**A303 Amesbury to Berwick Down  
(Stonehenge) Wiltshire  
TR010025**

**Wiltshire Council Written  
Representation**

**Anchor Retirement Flats Countess Court**

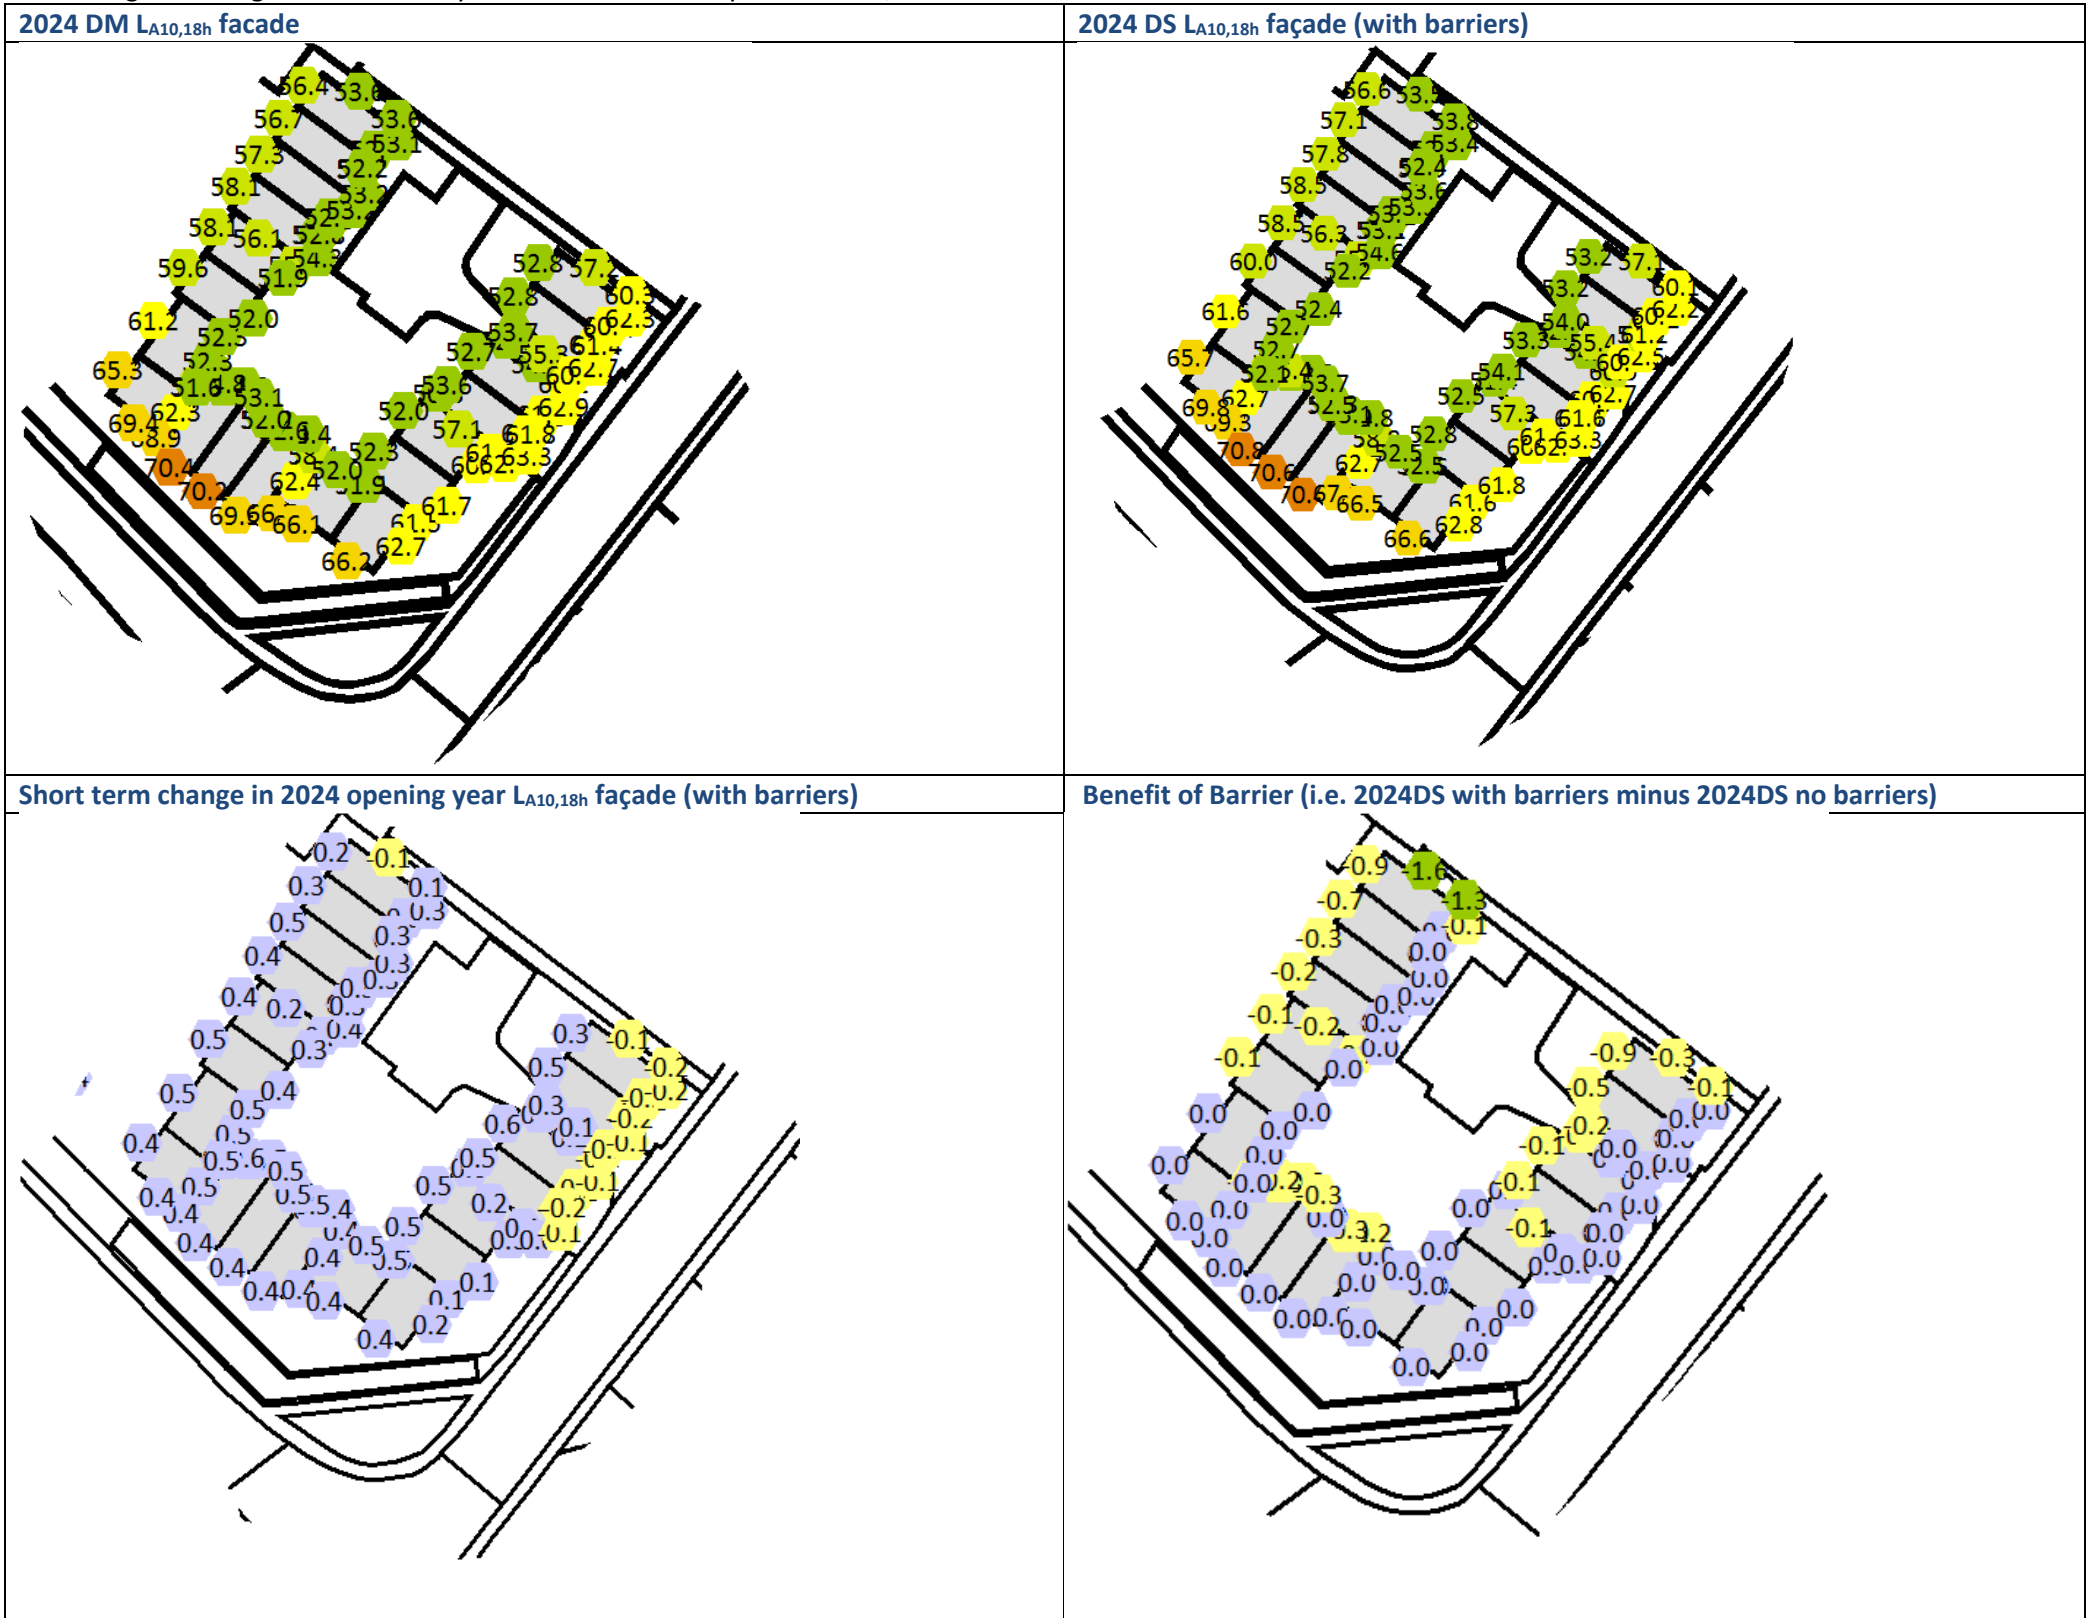
Mainly negligible increases in traffic noise levels due to slight increase in traffic on A345. Some negligible decreases facing London Road as traffic reduces slightly on this road, as discussed above. Barriers on flyover have minimal impact except on north-east façade of most northern property which has most direct view of the scheme.

**Conclusion for Anchor Retirement Flats Countess Court** – worst affected façades negligible increases in traffic noise levels therefore not identified as a significant adverse effect.

**Foredown House**

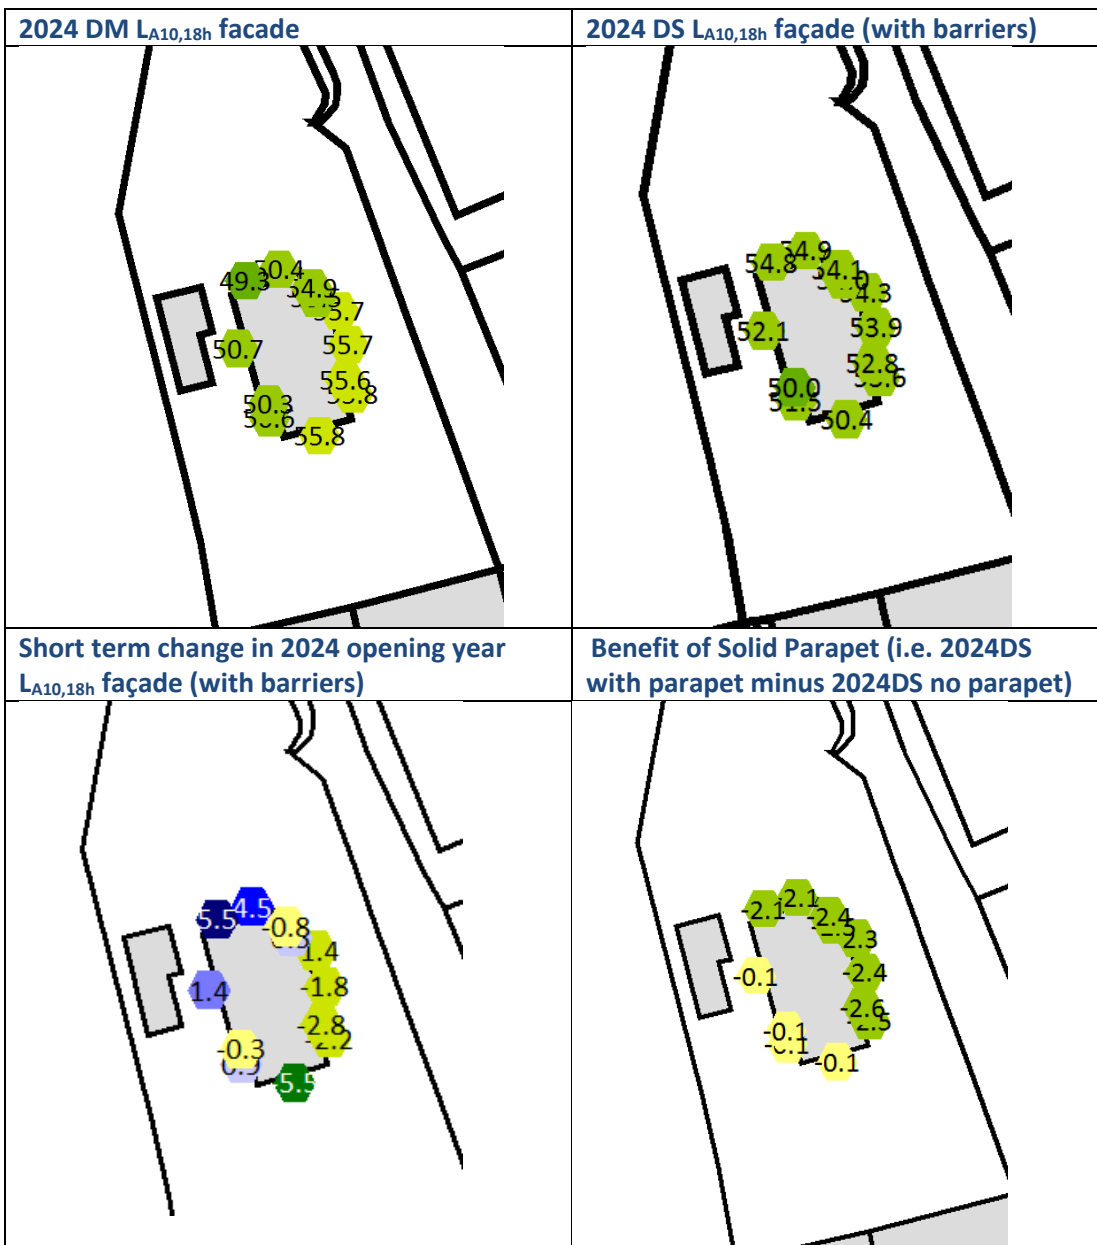
Very large reductions in traffic flows on existing A303 through the village to the south. New A303 to north over 200m away and in false cutting, solid parapet proposed on River Till viaduct and additional false cutting on eastern side of viaduct. Depth of false cutting increased through design process, though balanced against adverse landscape impacts. Barrier on River Till considered beneficial for noise but not essential mitigation, as only real benefit at a single property, cost benefit ratio very low. Similarly beneficial but not essential for landscape. Response from public consultation to question regarding a solid parapet on the River Till 75% in favour. Therefore solid parapet included in design. Major increase in traffic noise on north façade facing scheme and major reduction on south façade facing existing A303.

**Conclusion for Foredown House**– major increase on north façade facing scheme, therefore significant adverse effect identified.  
 Agreed – Note the level of noise is unlikely to breach WHO guidelines. Property may also have construction noise impacts.
